From: IALA
Reference: C60-9.5.9.2
24 April 2015

Liaison Note to ITU-R WP 5B

REGARDING THE JUSTIFICATION OF THE CHANNEL PLAN FOR VDES UNDER AGENDA ITEM 1.16

PRELIMINARY DRAFT NEW REPORT ITU-R M.[VDES-SELECT]

FIGURE 10

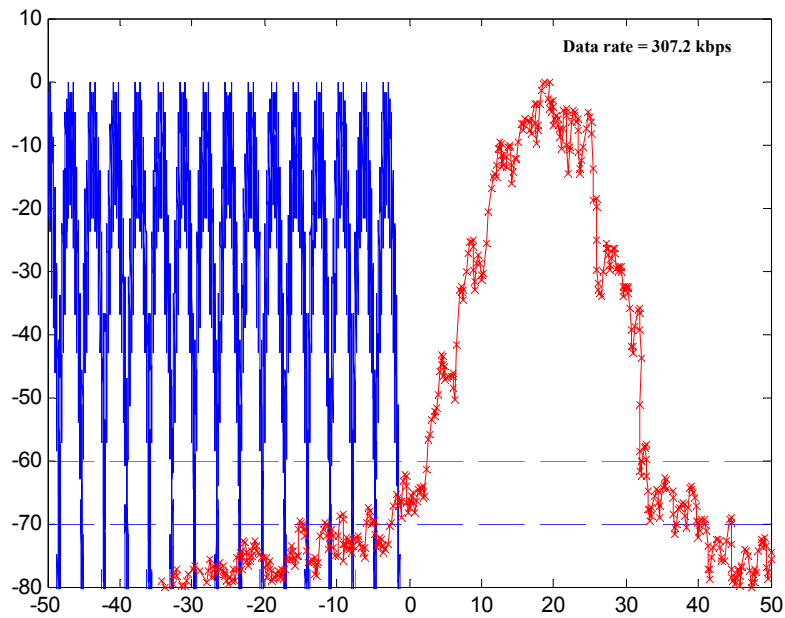
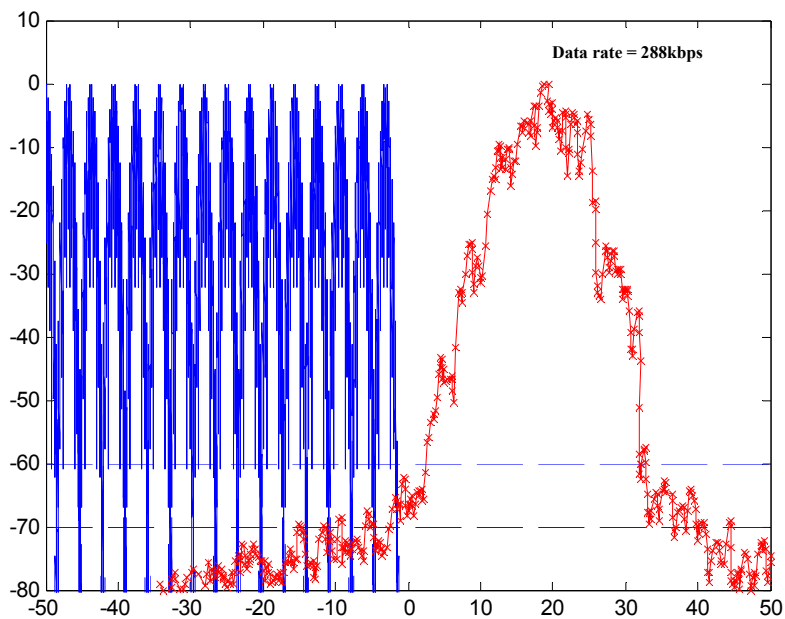
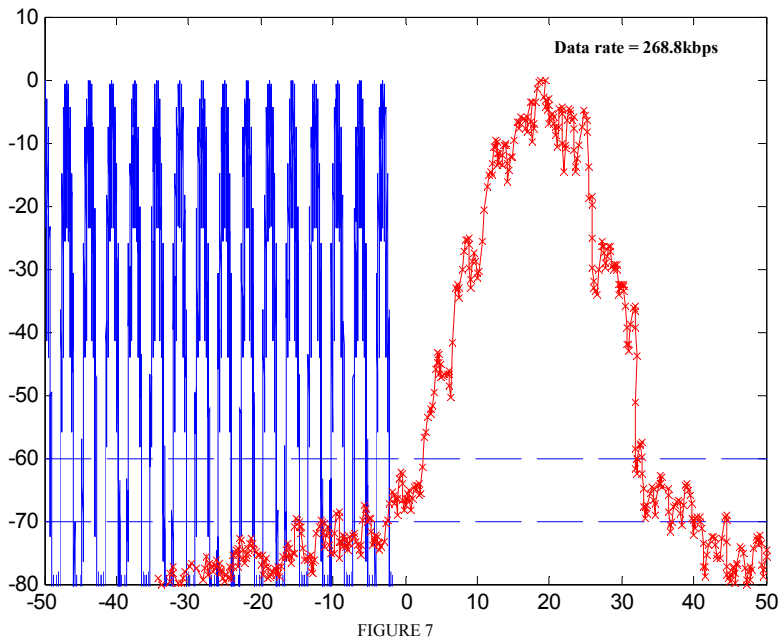
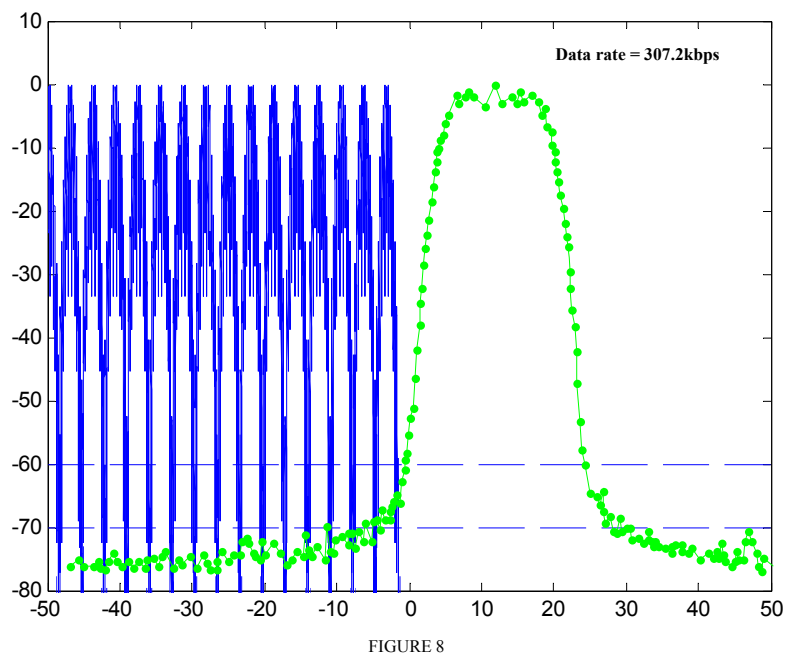
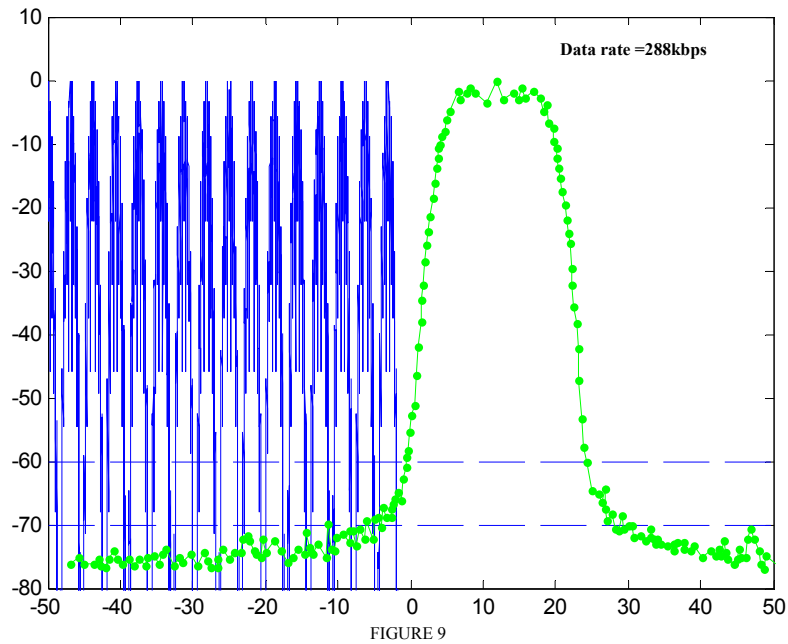
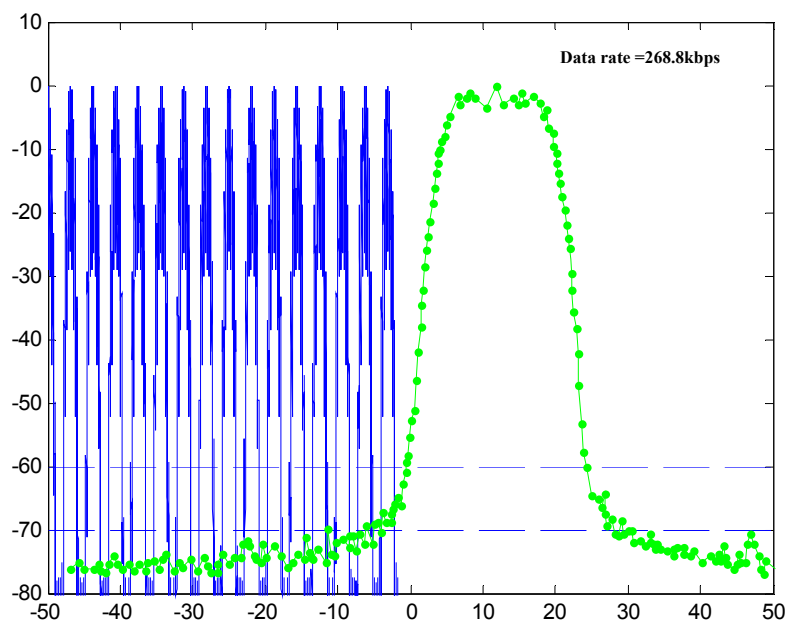
[Chairman's note: for consistency could the figure references and an added title be placed above the figure or previous figures have the reference moved below the figure]
